FOUNDATION INVESTIGATION REPORT

W.P. 88-78-10, Site 37-73-1113

Highway 407 Underpass at Martingrove Road

Re: Final Design Drawing Review
Hwy. 407 U'pass at Martingrove Rd.
Wp. 88-78-10, Site 37-1113
District 6, Toronto

TYPICAL X-SECTION 1:200

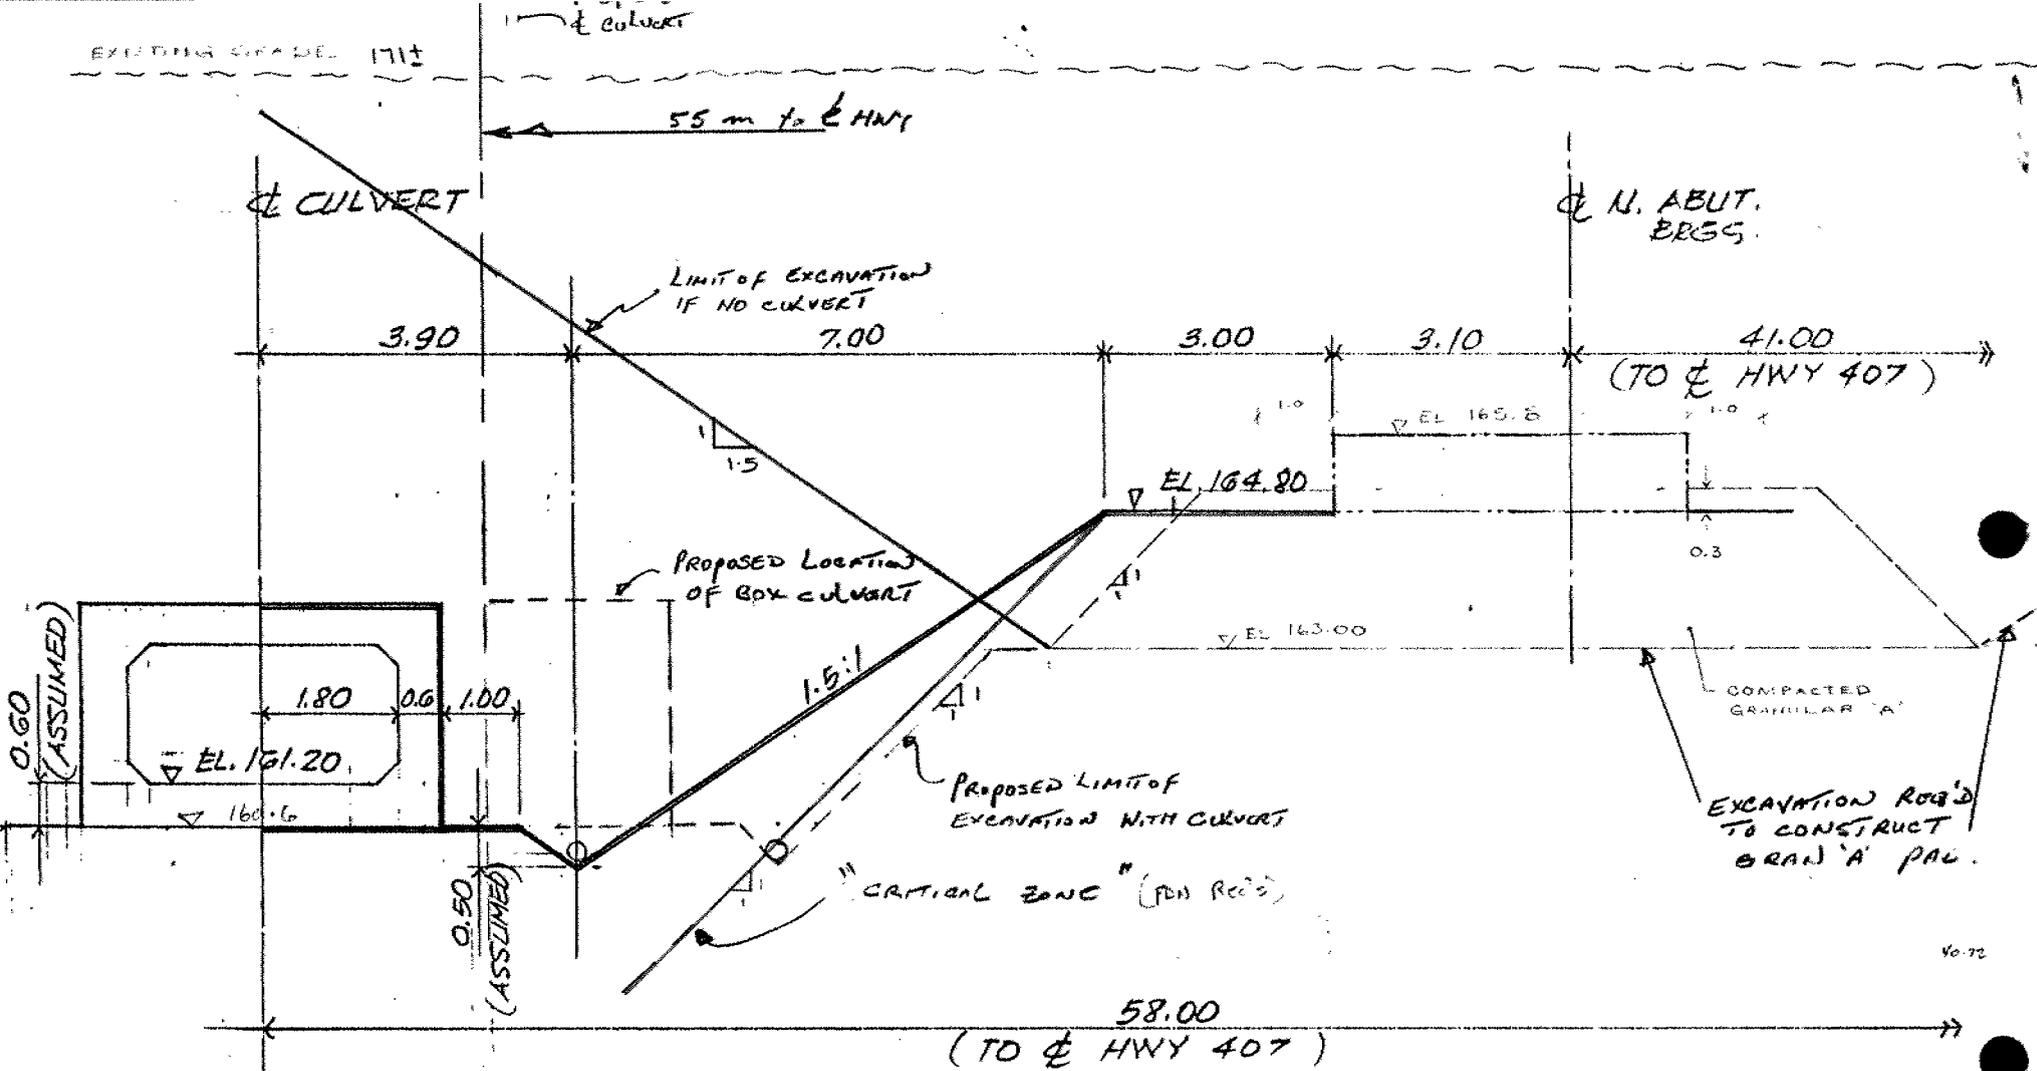
Please find attached a typical cross-section at the north abutment showing both the abutment footing and box culvert. We believe that your concerns expressed in your recent memorandum dated 1990-08-30 and our discussions have been properly addressed. We wish to highlight the following:

- a) The excavation slope between the Granular 'A' pad supporting the north abutment and the box culvert has been flattened to approximately 1.4H:1V by the use of a perforated pipe instead of an open ditch for groundwater control.
- b) The 0.2m thick granular blanket has been incorporated.
- c) The 1st stage of excavation has been limited to elevation 164.8 immediately below the abutment footing. The block of earth, which will be replaced by the Granular 'A' pad, will remain in place while the box culvert is constructed and will not be removed until the culvert has been partially backfilled. By doing this, we can better insure that the Granular 'A' pad will be placed soon after excavation to elevation 163.0 and the native material will not be exposed for a long period.

Please review the cross-section and notes and advise me if this proposal is acceptable. If yes, then we can proceed to incorporate the changes on the contract drawings. Thanks Tony.

In response to your memorandum dated 90 09 10, the proposal outlining the excavation scheme for the construction of the concrete box culvert adjacent to the bridge foundation as illustrated on the submitted sketch, is acceptable.

PLAN
1:250

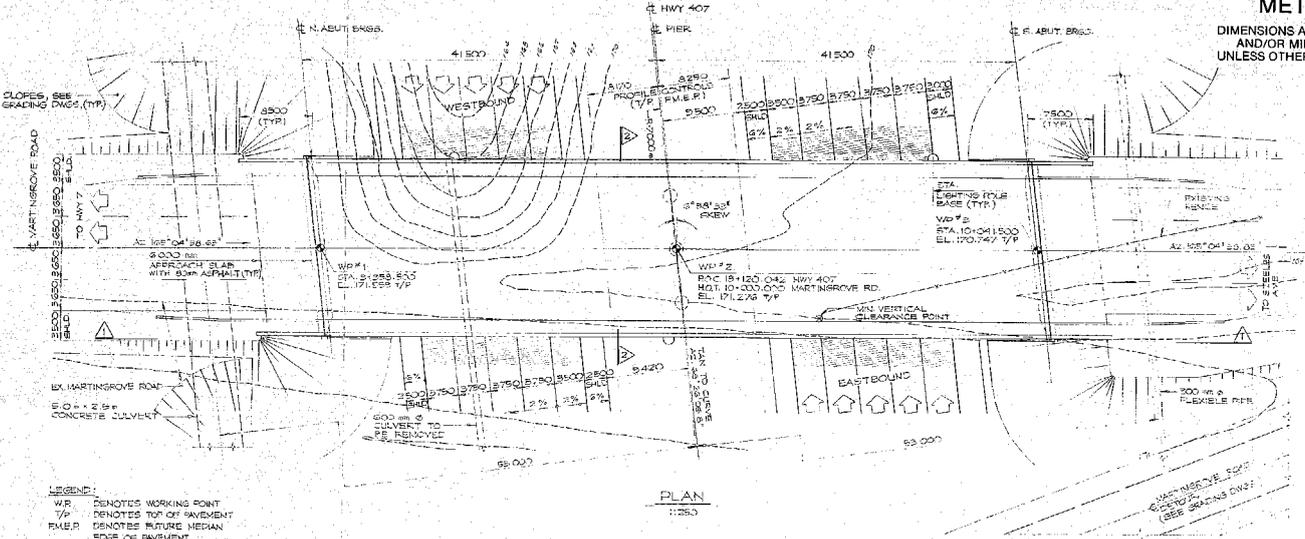
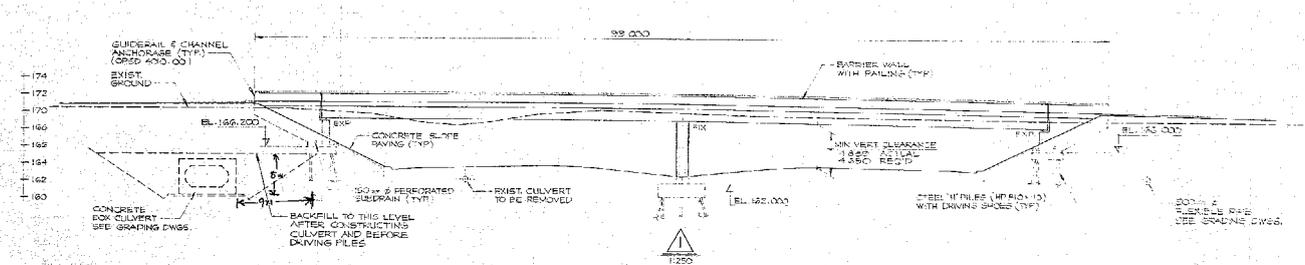
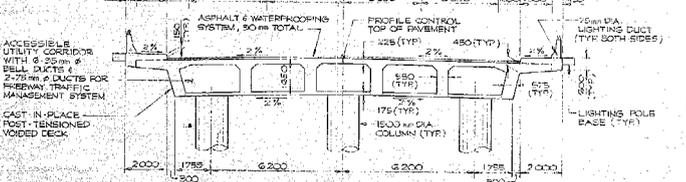
As shown on the drawing, piles will be driven after construction of the box culvert and back filling to the underside of abutment footing. Do you have any concerns that pile driving may cause settlement of the culvert and if so would it be more appropriate to drive piles prior to culvert construction? Kindly advise if the construction sequence as now detailed is acceptable or whether it should be revised. Thanks.

It is feasible to drive piles after the box culvert is constructed and backfilling around the culvert, up to the underside of the abutment footing is taken place. However, the piles should be driven through pre-augured holes. The pre-augured holes should extend to the founding elevation of the culvert which is about 5m below the underside of the north abutment footing.
